Title: **QUALITY AUDIT**

St. Michael's Development Dun Laoghaire.

Report reference: **0876R01**

Drawing D1855-C-01

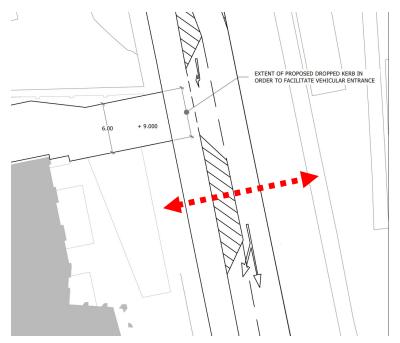
There will be a pedestrian desire line across Crofton Road from the development to get to the footpath and onwards to the bus stops or Dart station. There are no crossing facilities in close proximity to the development and as a result pedestrians will cross the wide carriageway.

It is recommended that an uncontrolled pedestrian crossing be provided between the right turning lanes with a refuge island. A footpath should be extended across the grassed area on the northern verge to ensure there is a continuous solid footpath linking with the existing network.

| Paragraph No. in Quality Audit Report | Problem accepted (yes/no) | Recommended measure accepted (yes/no) | Alternative measures (describe) | Alternative measures accepted by Auditors (Yes/No) |
|---|---------------------------|--|---|--|
| 3.1 Yes No | | No | Such a pedestrian crossing is outside the scope of the proposed development. However, the applicant would support the provision of a pedestrian crossing at this location by Dun Laoghaire Rathdown County Council. | Yes |
